Subject Area
Sorrento Activity Centre
2 Drakes Walk, Sorrento
2 & 4 Padbury Circle, Sorrento
128, 130, 134 & 136 West Coast Drive, Sorrento

Draft Sorrento Precinct Structure Plan - schedule of submissions

DRAFT SORRENTO PRECINCT STRUCTURE PLAN
City of Joondalup recommended modifications

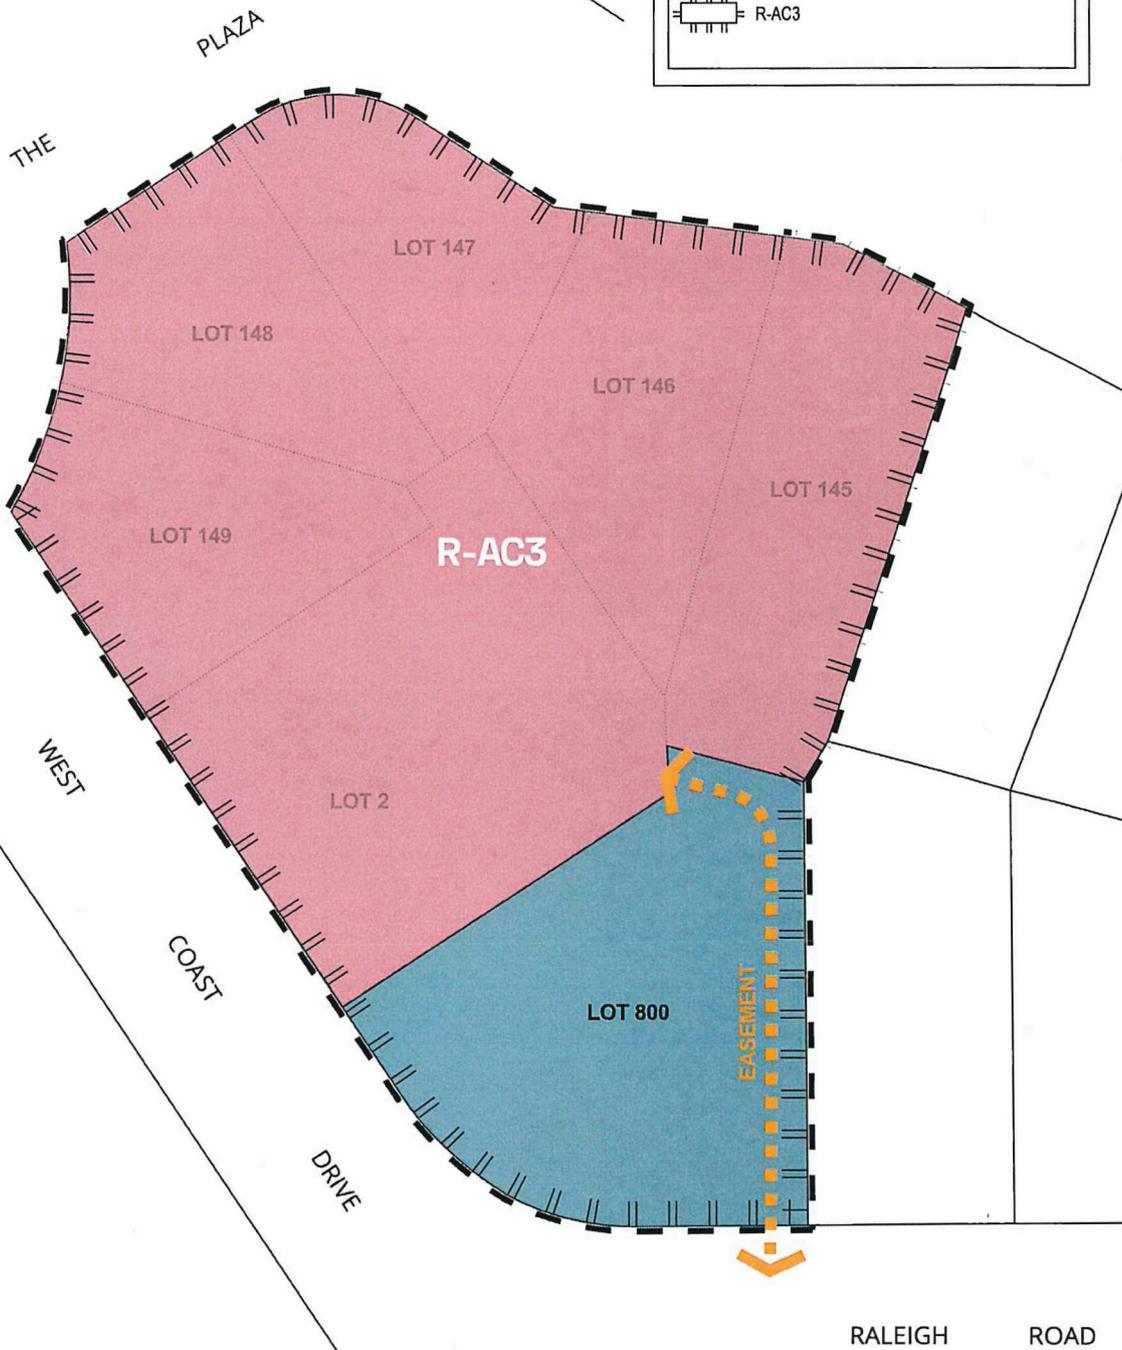
Plan 2 – Built Form Controls Tower Plan	<ul style="list-style-type: none"> Additional height proposed through community benefits is not supported. Lot 145 (2) Drakes Walk is to provide an appropriate transition to the lower density residential area. The setback to the eastern boundary is to provide an appropriate transition to the lower density. 	<ul style="list-style-type: none"> Modify building height for Lot 145 (2) Drakes Walk to be three storeys. Modify built form as shown to provide a 3.0m setback between Lot 145 and Lot 91.
PART TWO – EXPLANATORY REPORT		
Figures 1-3	<ul style="list-style-type: none"> The images provided within the figures are outdated. 	<ul style="list-style-type: none"> Update images to reflect current 2022 aerial mapping.
